Access Compliance Report

Public Rights-of-Way

Intersection ID: 3105	Main Street: DEARMON_RD	Cross Street: BROWNE_RD	Location: SW
ADA ID: 14446DA90244	Ramp Type: Perp	Initial Pass/Fail: Fail	Overall Compliance: No
Severity Score: 33.75			
Codes/Mitigation Info/Possible Solution		Field Measurements/Component Compliance

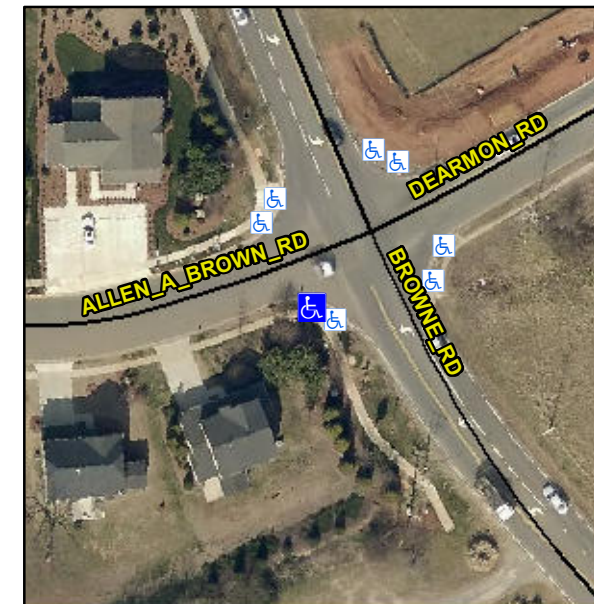
R304.5.1, R304.2.2

Compliance	Description	Data	Compliance	Description	Data
N/A	Ramp Length (in)	51.5	No	Ramp Slope (%)	15.2
No	Ramp Width (in)	47.0	Yes	Ramp XSlope (%)	0.4
N/A	Flare Type LT	N/A	N/A	Flare Type RT	N/A
N/A	Flare Slope LT (%)	N/A	N/A	Flare Slope RT (%)	N/A
N/A	Flare Traversable LT?	N/A	N/A	Flare Traversable RT?	N/A
N/A	Landing Length (in)	N/A	N/A	DWS Provided?	N/A
N/A	Landing Width (in)	N/A	N/A	DWS Contrast?	N/A
N/A	Landing Slope (%)	N/A	N/A	DWS Length (in)	N/A
N/A	Landing X Slope (%)	N/A	N/A	DWS Full Width?	N/A
N/A	Landing Curb? (Y/N)	N/A	N/A	DWS Offset (in)	N/A
N/A	Shared Landing?	N/A			
N/A	Gutter Ponding?	N/A	N/A	Gutter Slope (%)	N/A
N/A	Gutter Lip Ht (in)	N/A	N/A	Gutter X Slope (%)	N/A
N/A	Painted X Walk1?	Yes	N/A	Painted X Walk2?	N/A
	X Walk 1 Direction	To N		X Walk 2 Direction	N/A
N/A	X Walk 1 Width (in)	106.0	N/A	X Walk 2 Width (in)	N/A
	X Walk 1 Slope (%)	3.1		X Walk 2 Slope (%)	N/A
	X Walk 1 X Slope (%)	2.0		X Walk 2 X Slope (%)	N/A

Remove & Replace Entire Ramp.
